APPLICATION FOR PERMISSION  
UNDER SECTION 16 OF  
THE TOWN PLANNING ORDINANCE  
(CAP. 131)

For Official Use Only 請勿填寫此欄	Application No. 申請編號	A/NE-HLH/71
	Date Received 收到日期	22 DEC 2023

## **SECTION 16 PLANNING APPLICATION**

## Response to Comments

Figure 2 Drainage Plan

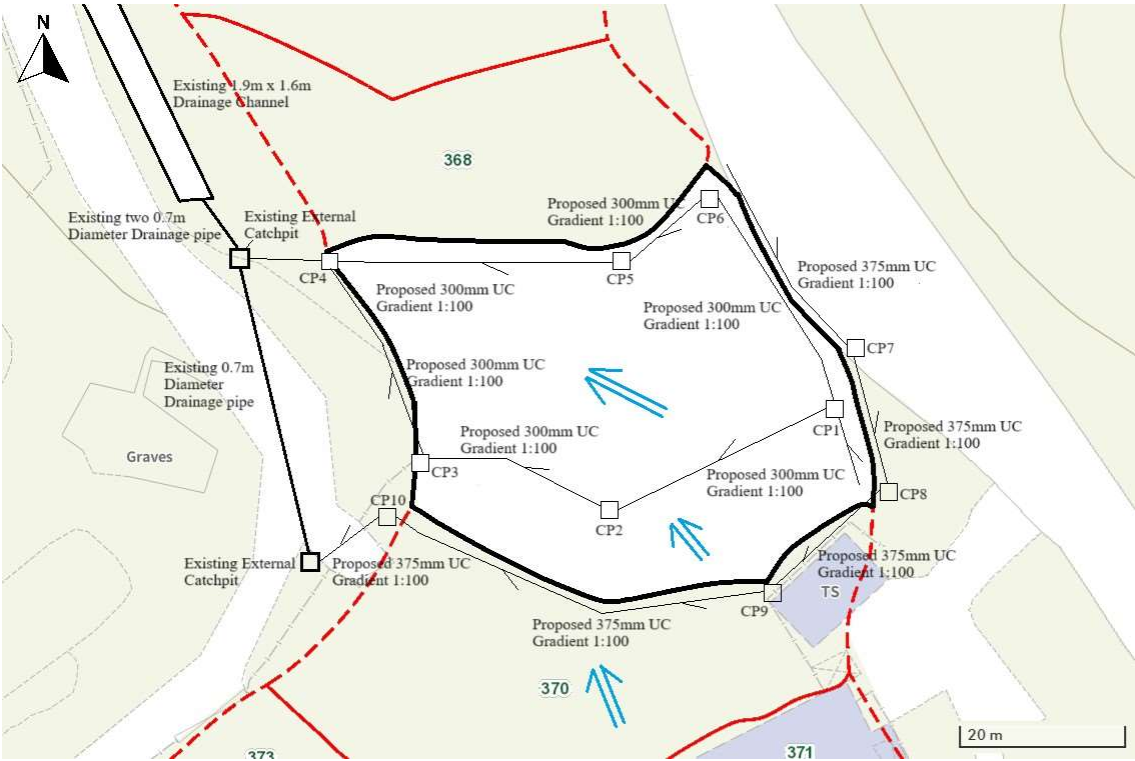
<p>d) Surface channel with grating covers should be provided along the site boundary.</p>	<p>Noted, surface channel with grating covers will be provided along the site boundary as shown in the revised drainage plan.</p>

i) Where walls are erected or kerbs are laid along the boundary of the same, peripheral channels should be provided at the walls/kerbs to allow existing overland flow passing through the site to be intercepted by the drainage system of the site with details to be agreed by DSD, unless justified not necessary.	Please find revised drainage plan with peripheral channels at the walls and kerbs to intercept and discharge existing overland flow passing through the site

- 2.1.2 The intercepted stormwater from the site will then be discharged to the existing drainage to the northwest of the application site as shown in Figure 1, and eventually discharges into an natural watercourse to the north. The intercepted stormwater from the external catchment will be discharged into an existing catchpit to the Southwest of the site.

Photo 016

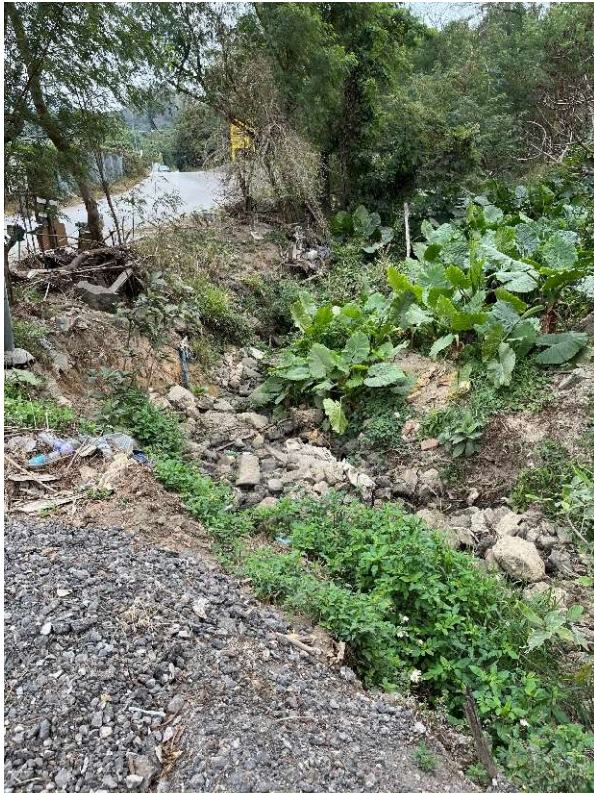
h) The applicant should check and ensure that the existing drainage downstream to which the proposed connection will be made have adequate capacity and satisfactory condition to cater for the additional discharge from the captioned site. He should also ensure that the flow from this site will not overload the existing drainage system. Please provide further substantiation on the assumptions made on the checking of capacity of the natural stream.	The proposed drainage system will discharge into an existing external catchpit, which, using two 0.7m diameter pipes, discharges into a 1.9m wide x 1.6m deep drain before discharging into a 2.5m wide x 1.6m deep watercourse. The capacity of downstream drainage and watercourse is calculated in the attached drainage proposal, the capacity of the natural stream is calculated based on the watercourse is a canal with rough stony beds, weeds on earth beds in bad condition, with $n=0.04$ . Conditions of the watercourse is shown in photos 016 and 017.

Appendix III: Swept Path Analysis

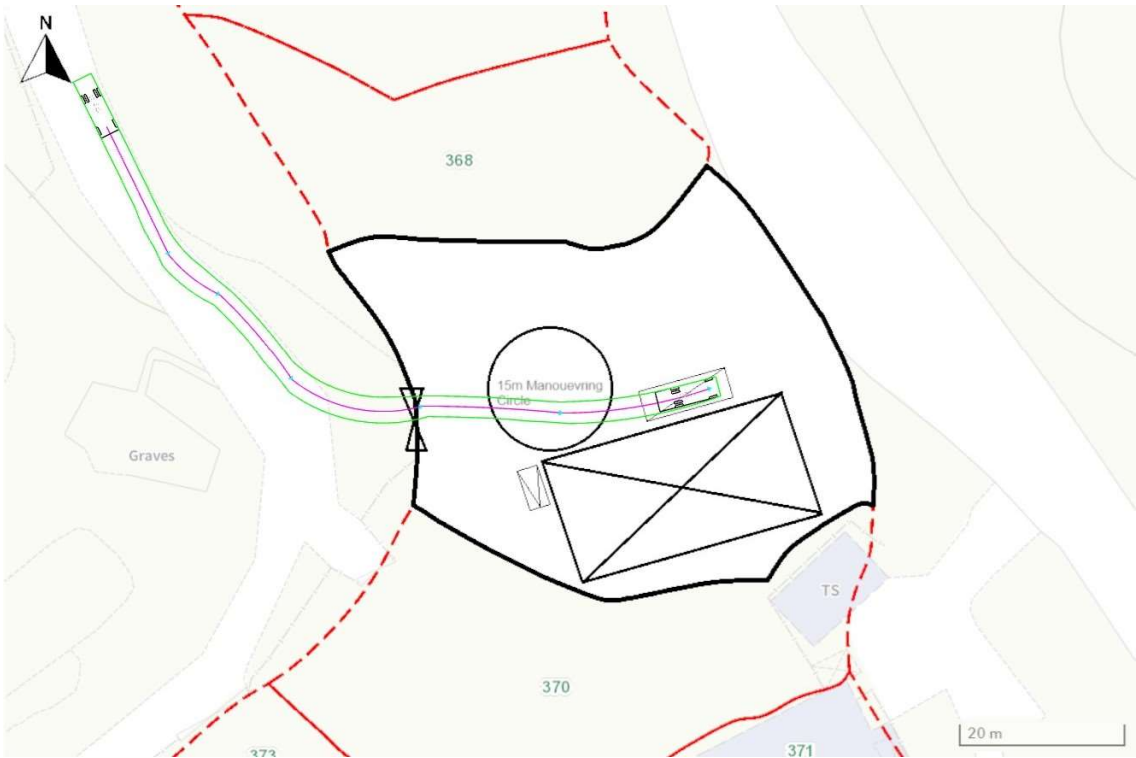
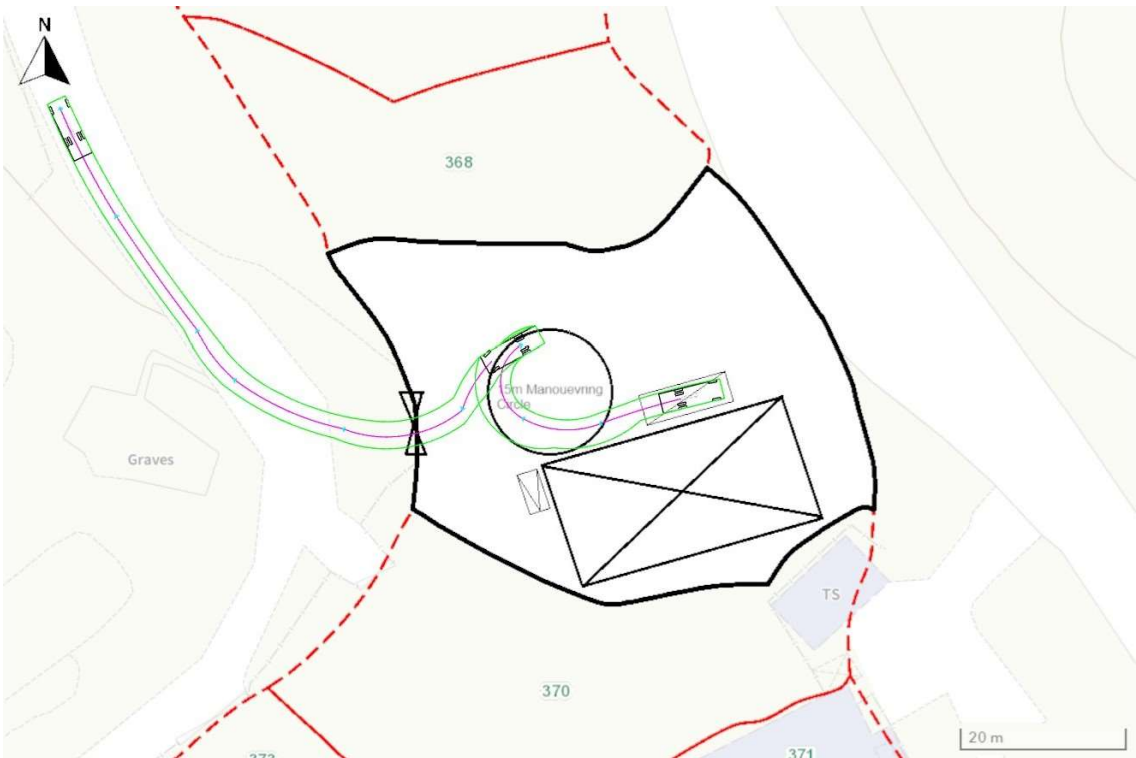
- having reviewed the further information, she has no comment from traffic engineering viewpoint.

Figure 1 Revised Drainage Plan

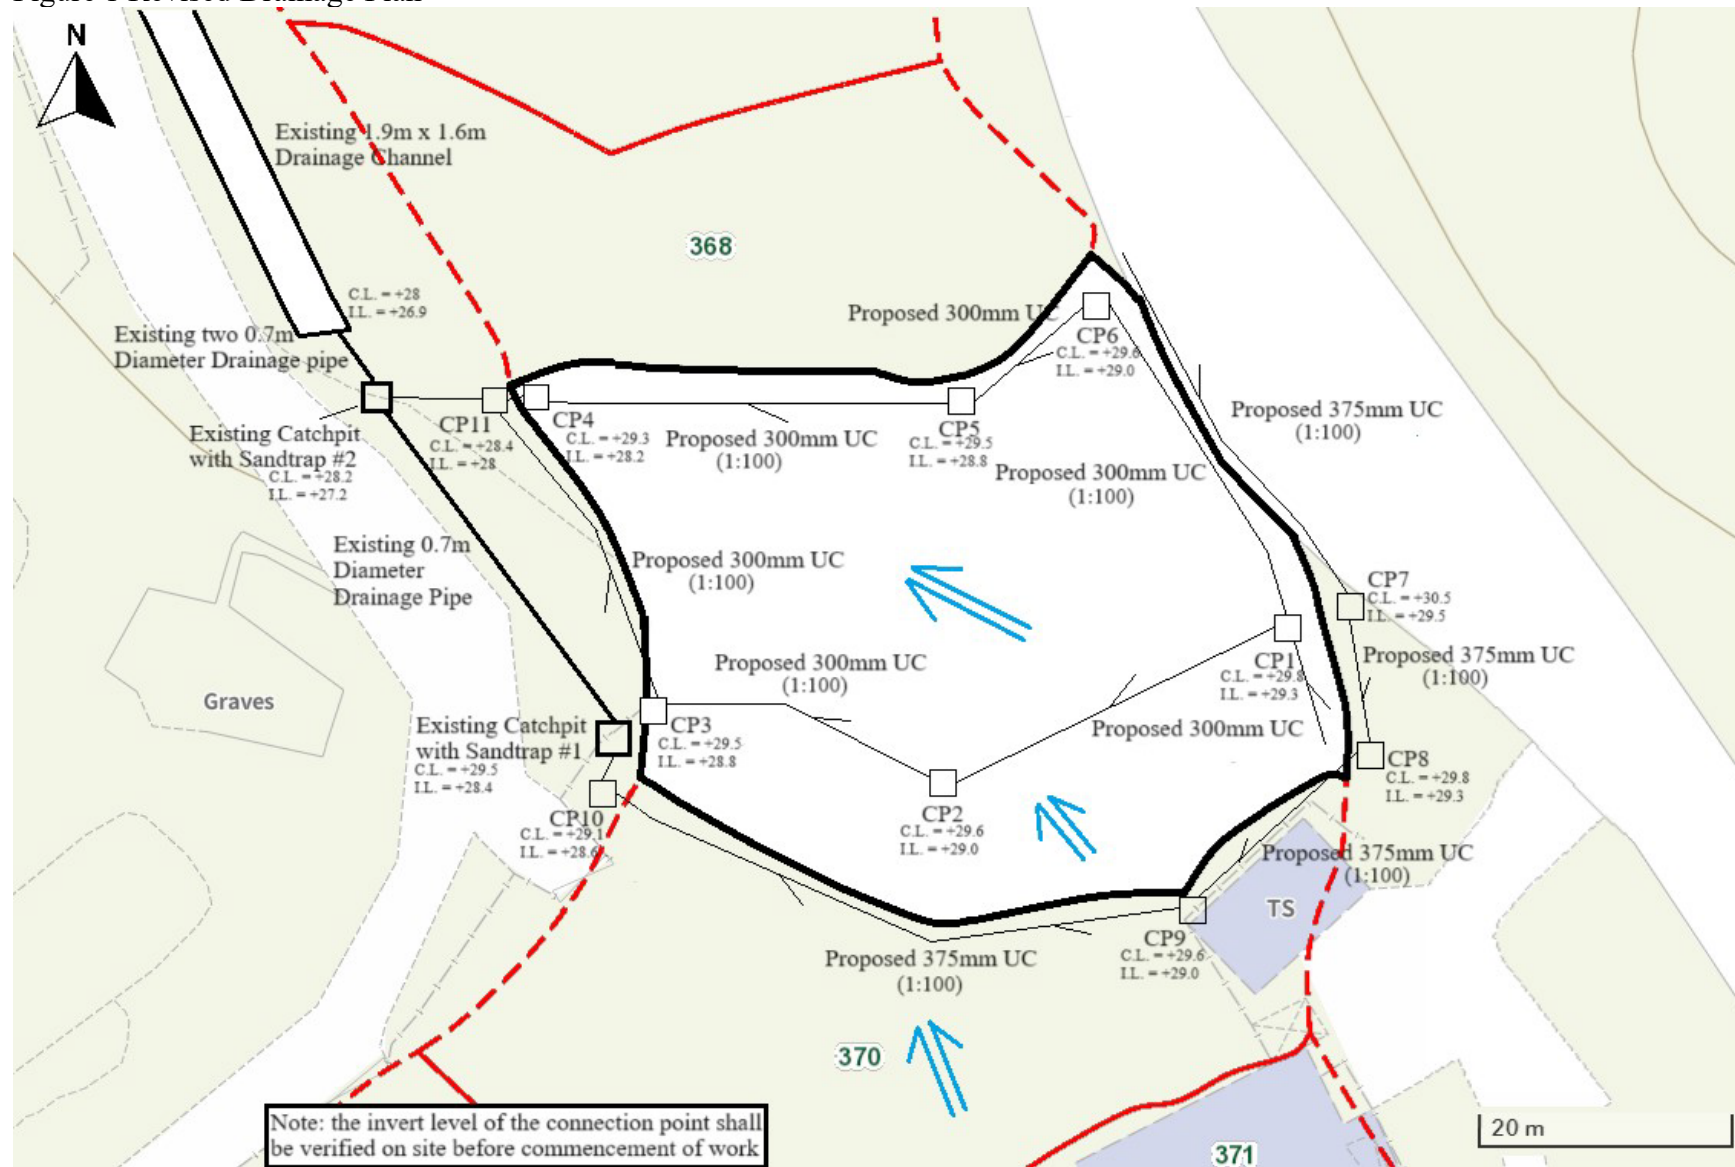
3. Section 6 of drainage proposal refers. Two existing drainage channel are mentioned while only one is indicated in the Figure 2, please clarify.

Departmental Comments	Applicant's Response
<p><u>Comments from Drainage Services Department</u></p> <p>1. Please check and advise if the existing 0.7m diameter pipe has adequate capacity and in satisfactory condition to cater for the additional discharge from the site and associated external catchment area. Also, please advise the existing upstream catchment area of the existing 0.7m dia. Drainage pipe</p>	<p>Please find attached calculations that shows the existing 0.7m diameter pipe has adequate capacity and in satisfactory condition to cater to the existing upstream catchment area as well as the additional discharge from the site and associated external catchment area.</p>
<p>2. Please indicate the invert levels and catchpit types in the drainage proposal. Especially please specify the catchpits with sand trap</p>	<p>Please find below revised Drainage plan with Invert levels and catchpit types, Figure 1.</p>

<p>3. Section 6 of the drainage proposal refers. Two existing drainage channel are mentioned while only one is indicated in the Figure 2, please clarify</p>	<p>There is only One existing drainage channel, please find the revised section 6 of the drainage proposal.</p>
<p>4. Please provide photos of the existing catchpits proposed for connection to the west of the proposed development.</p>	<p>Please find attached photos of the existing catchpits proposed for connection to the west of the proposed development, Figures 2-4</p>
<p>5. The “existing catchpit, pipe and channel” to which the applicant proposed to discharge the storm water from the subject site is not maintained by this office. Consent from the owner/maintenance party, current users and DO/N should be sought for the proposed drainage connection. Moreover, regular maintenance should be carried out by the applicant to avoid blockage of drain.</p>	<p>Noted. The applicant will seek consent from the responsible parties for the proposed drainage connection, and the applicant will perform regular maintenance to avoid blockage of the drain. In particular, the sand traps will be cleared regularly.</p>
